PERMIT

SEWAGE DISPOSAL SYSTEM

PROPERTY OWNER Mount Hebron Presbyterian Church

SEWAGE DISPOSAL TESTING

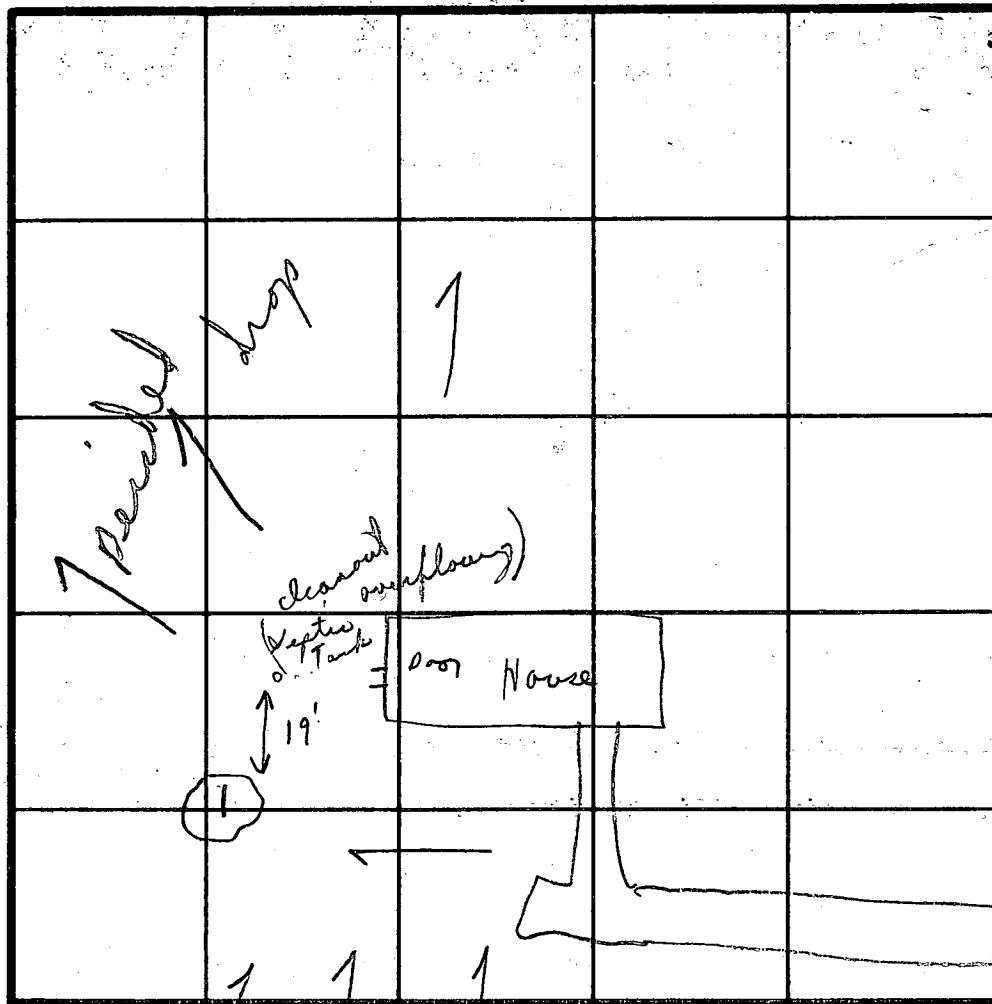
Repair existing house 4/12/79 recommend a 15' x 15' dry well
REASONS FOR REJECTION OR HOLDING inlet 2' and maximum depth - 10' location in D. hole
area 19' towards church from septic tank cleanout
and stay at least 20' off any part of house. C.B.D. Limited area - see dry well
